TRANSMITTAL OF MEETING HANDOUT MATERIALS FOR IMMEDIATE PLACEMENT IN THE PUBLIC DOMAIN

Catawba Nuclear Station, Units 1 and 2

To discuss the results of control room
in-leakage testing at Catawba, and to discuss
partial implementation of alternate source
term application at Catawba

**CATAWBA NUCLEAR STATION
FHA AND WEIR GATE DROP ACCIDENT
REG GUIDE 1.183 APPENDIX B ANALYSIS
PRESENTATION TO NRC
FEBRUARY 21, 2002**

SCALE 1" = 100'
DUKE POWER
CATAWBA NUCLEAR STATION
PLOT PLAN FOR
CONTROL ROOM HABITABILITY
ASSESSMENT
FIGURE: 1

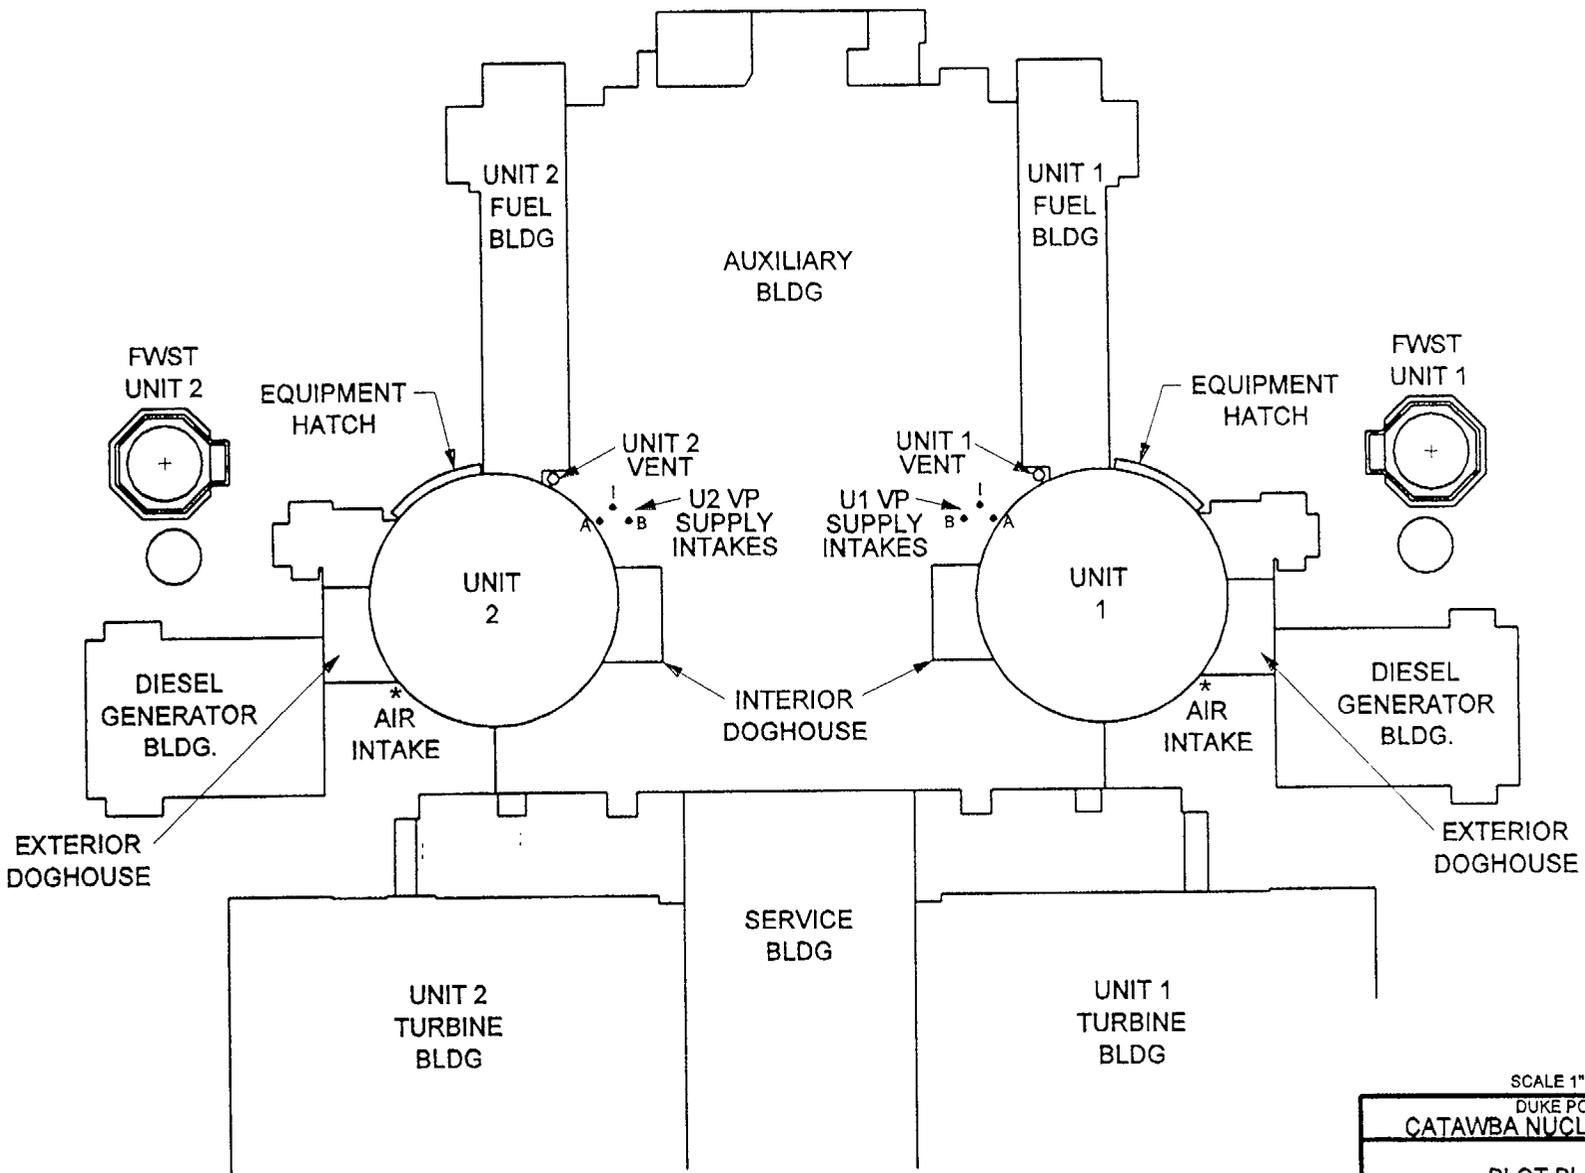
- Values of zero are assumed for the vertical velocity and stack radius parameters, in order to treat the release as a ground-level release in ARCON96.
- **Figure 1 from the calculation is being provided in hardcopy, showing the plot plan of Catawba Nuclear Station.**

All wind directions are measured from True North. The difference between station north and True North is noted on **Figure 1** as 1 degree 11 minutes and 5 seconds west of station north at CNS.
